UNITED STATES PATENT AND TRADEMARK OFFICE

APPLICATION NO.	FILING DATE	FIRST NAMED INVENTOR	ATTORNEY DOCKET NO.	CONFIRMATION NO.
10/618,040	07/11/2003	Eiji Itoi	SOHMEI.PT1006	4117

Office Action Summary

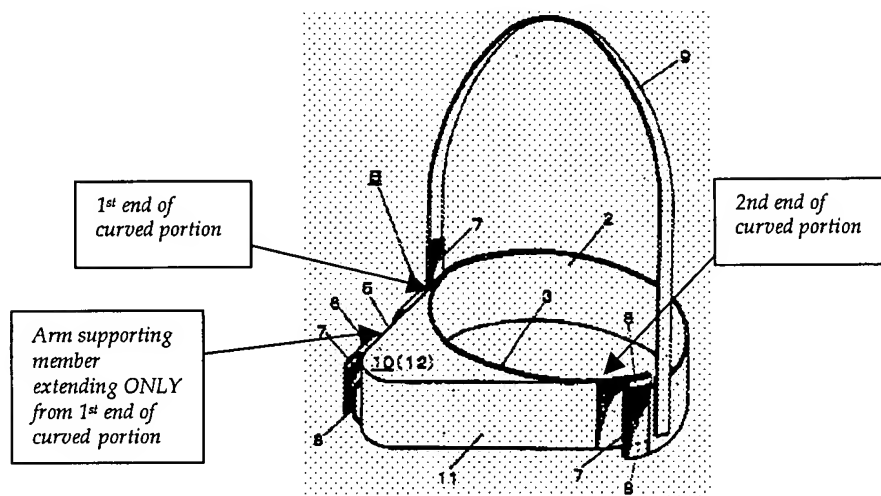
4. The drawings are objected to under 37 CFR 1.83(a). The drawings must show every feature of the invention specified in the claims. Therefore, the “flank sides” claimed in claim 4, and the subject matter of claim 5 must be shown or the feature(s) canceled from the claim(s). No new matter should be entered.

- On page 7 of the specification, Applicant states that the arm supporting side face (5) “is extended forward from both ends of the curved portion 3”. This appears to be contrary to the relevant drawings provided. See the marked up Figure below. The arm supporting side face extends forward from one end of the curved portion only. The arm supporting side face does not extend forward from the second end of the curved portion at all. It is unclear what this language, in light of the drawings, means.

- Also on page 7, the description of the arm supporting side face as extending forward from a “flank side”, with an inclined surface extending from “the other flank side”, is unclear. It is unclear to the examiner what “flank side” is referred to; whether it is a “flank side” of the user, a “flank side” of the device, or some other “flank side” altogether. Neither the specification nor the drawings provide any further clarification.

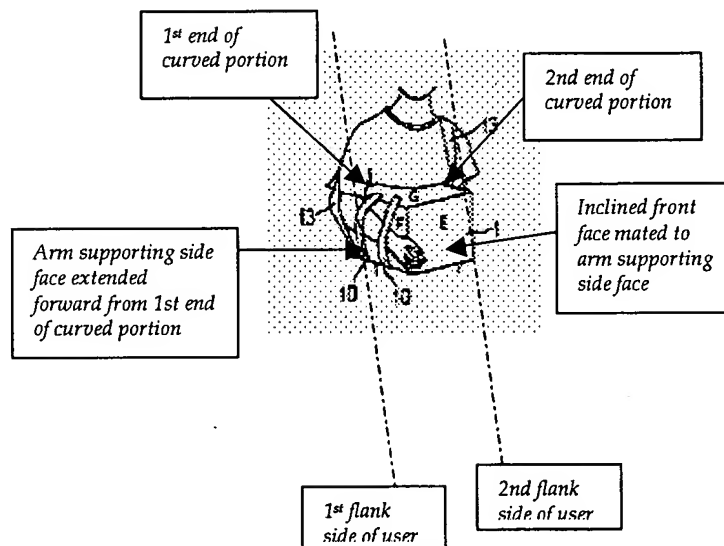
Tatsuya et al. disclose a shoulder dislocation acute-phase immobilization orthosis as shown in Figures 4a and 4b comprising:

a roughly triangular support block (1) formed of a lightweight hard synthetic resin material (such as styrene foam), with a width approximately greater than that of the forearm (see width of forearm versus width of support block in Figures 4a-b), comprising:

a curved portion (D) having two ends, which follows the shape of an abdominal part of a body;

an arm supporting side face (F) of approximately a forearm length (see length of forearm versus length of support block in Figures 4a-b), which is extended forward from a first

end of the curved portion to create an angle of inclination within an range of approximately 5°~10° outward from at least one of a plurality of flank sides of the user, with respect to a surface extended forward in parallel with a flank side of the user, and an inclined front face (E) mated to said arm supporting side face from the other flank side of the user;
